STAFF RECOMMENDATION
1522 Douglas Avenue
February 19, 2020

Application: New Construction—Addition; Setback Determination
District: Eastwood Neighborhood Conservation Zoning Overlay
Council District: 06
Base Zoning: R6
Map and Parcel Number: 08302020400
Applicant: Eric Madej, contractor
Project Lead: Sean Alexander, sean.alexander@nashville.gov

Description of Project: An application to construct a rear addition to an historic house. The addition will match the width of the existing house, which is closer to the right side property line than the current bulk zoning regulation permits. The applicant requests a three foot (3') right side setback.

REAR ELEVATION

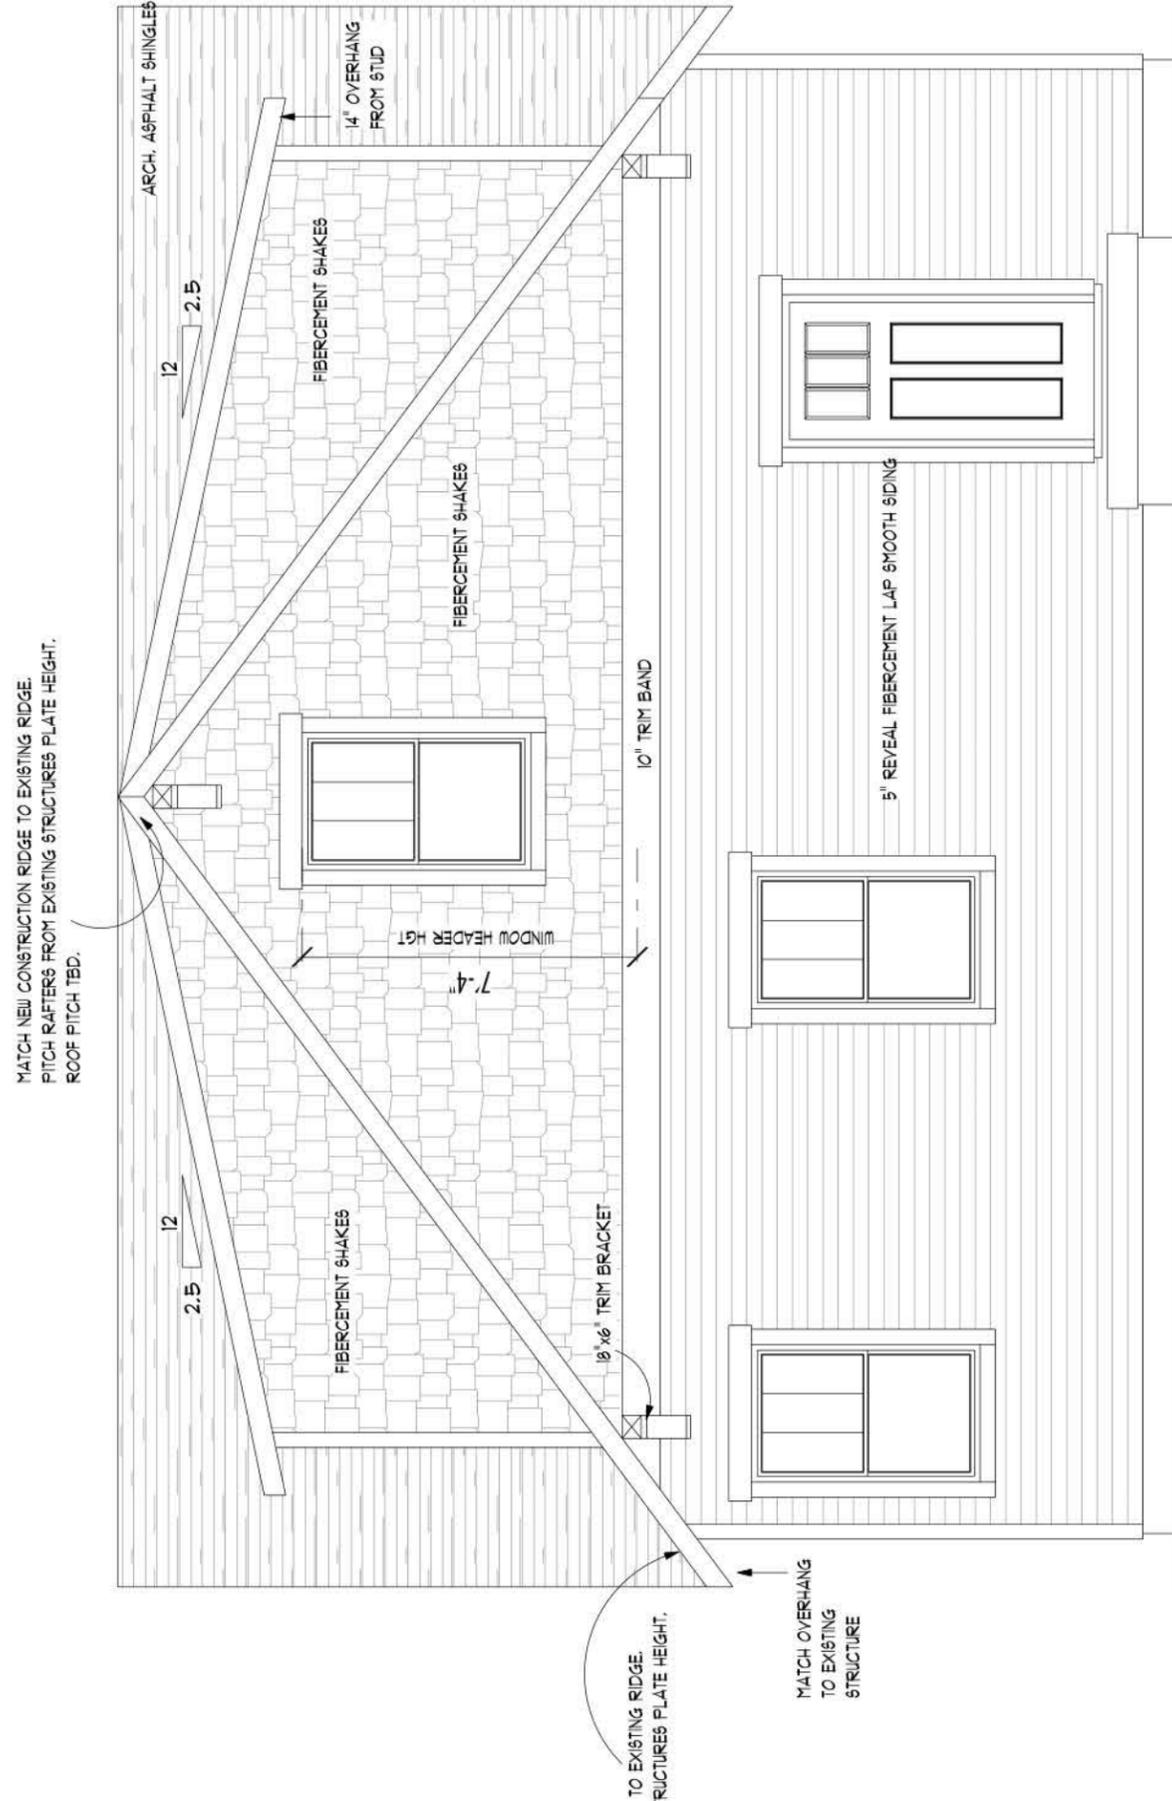
Roof form: The primary roof of the addition will be a rear-facing gable, tying into the ridge of the existing side-gabled roof. From the new ridge there will be shed-roofed dormers on both sides. The pitch of the gable will match the 6/12 pitch on the historic house, and the shed dormers will have a pitch of 4/12.

Appurtenances & Utilities: The location of the HVAC and other utilities was not noted. Staff asks that if the HVAC are relocated that they are located on the rear façade, or on a side façade beyond the midpoint of the house. With this condition, Staff finds that the project meets section II.B.1.i of the design guidelines.

RIGHT ELEVATION

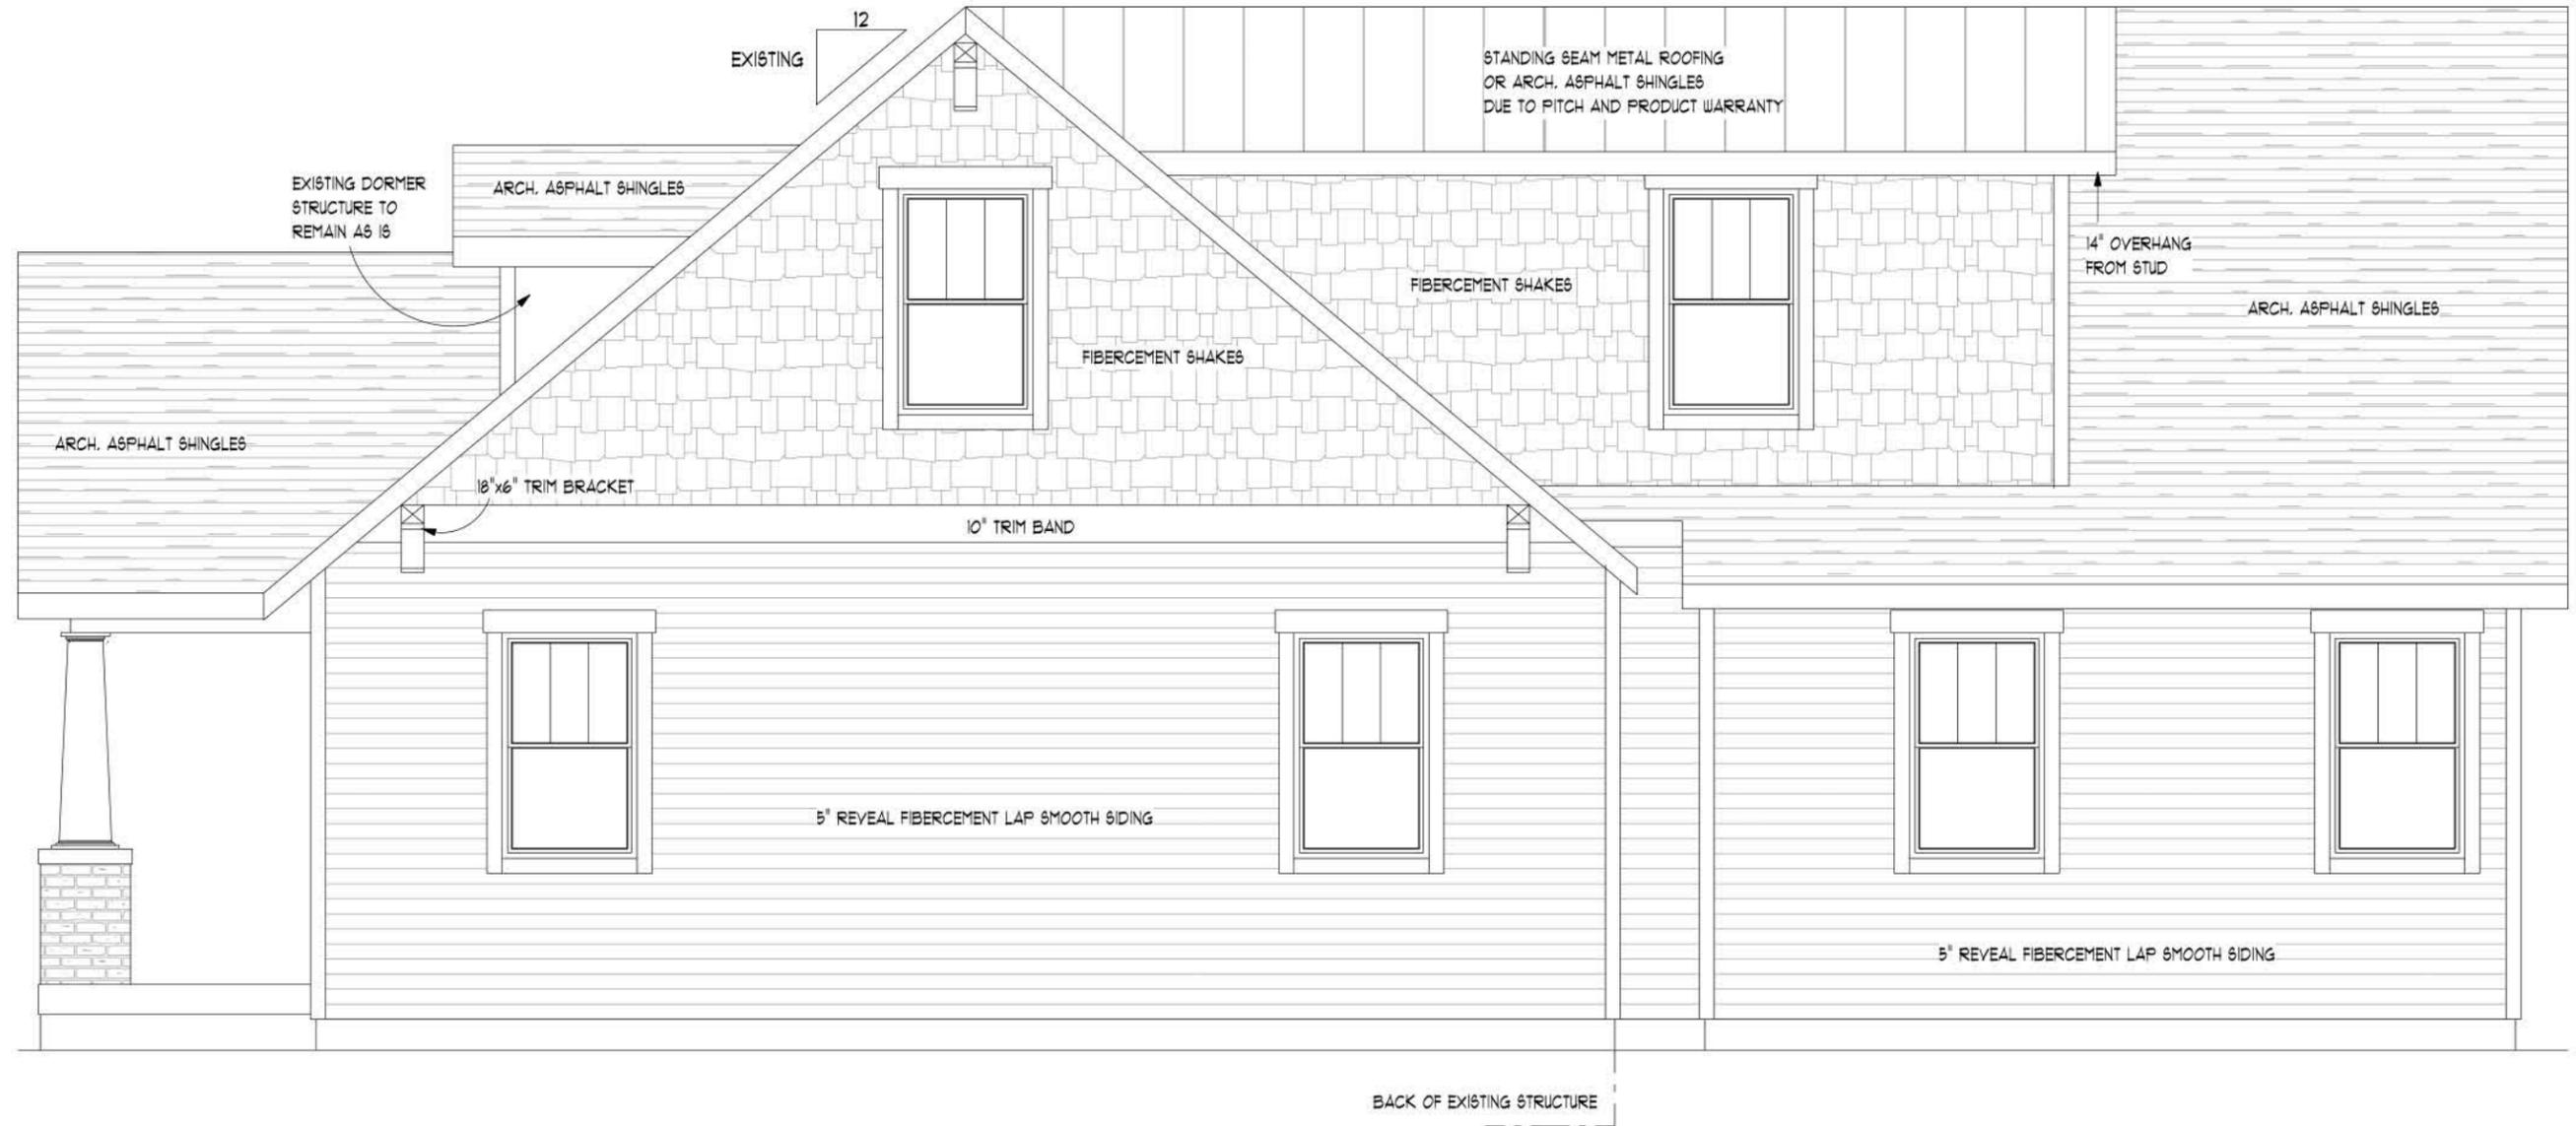
1. The original window opening on the right side of the house shall be retained; and
2. Brick, roofing, and window selections shall be administratively approved prior to installation; and
3. The HVAC shall be located behind the house or on either side, beyond the mid-point of the house.

Setback & Rhythm of Spacing: The proposed addition will match the width of the historic house. However, the historic house sits only three feet (3') from the right side property line whereas the current bulk zoning regulations require a side setback of five feet (5'). Because the addition does not increase the width of the house and matches the historic condition, staff finds the proposed setback to be appropriate.
